Access Compliance Report

Public Rights-of-Way

Intersection ID: 26566	Main Street: ARBORHILL_RD	Cross Street: STIRRUP_RIDGE_LN	Location: SW
ADA ID: 57C8270C06DD	Ramp Type: Perp	Initial Pass/Fail: Fail	Overall Compliance: No
			Severity Score: 10

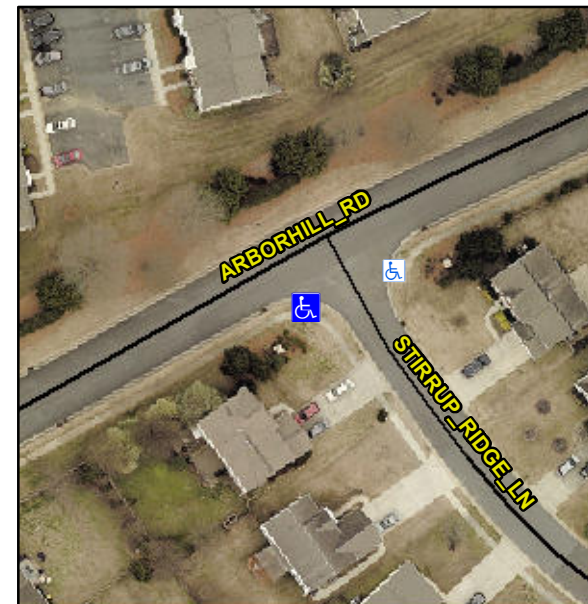
Not Found, R304.5.1, R304.5.3

Compliance	Description	Data	Compliance	Description	Data
N/A	Ramp Length (in)	48.0	Yes	Ramp Slope (%)	5.8
No	Ramp Width (in)	47.0	No	Ramp XSlope (%)	3.4
N/A	Flare Type LT	N/A	N/A	Flare Type RT	N/A
N/A	Flare Slope LT (%)	N/A	N/A	Flare Slope RT (%)	N/A
N/A	Flare Traversable LT?	N/A	N/A	Flare Traversable RT?	N/A
N/A	Landing Length (in)	N/A	N/A	DWS Provided?	N/A
N/A	Landing Width (in)	N/A	N/A	DWS Contrast?	N/A
N/A	Landing Slope (%)	N/A	N/A	DWS Length (in)	N/A
N/A	Landing X Slope (%)	N/A	N/A	DWS Full Width?	N/A
N/A	Landing Curb? (Y/N)	N/A	N/A	DWS Offset (in)	N/A
N/A	Shared Landing?	N/A			
N/A	Gutter Ponding?	N/A	N/A	Gutter Slope (%)	N/A
N/A	Gutter Lip Ht (in)	N/A	N/A	Gutter X Slope (%)	N/A
N/A	Painted X Walk1?	No	N/A	Painted X Walk2?	N/A
	X Walk 1 Direction	To W		X Walk 2 Direction	N/A
N/A	X Walk 1 Width (in)	N/A	N/A	X Walk 2 Width (in)	N/A
	X Walk 1 Slope (%)	0.7		X Walk 2 Slope (%)	N/A
	X Walk 1 X Slope (%)	3.0		X Walk 2 X Slope (%)	N/A

Remove & Replace Entire Ramp.
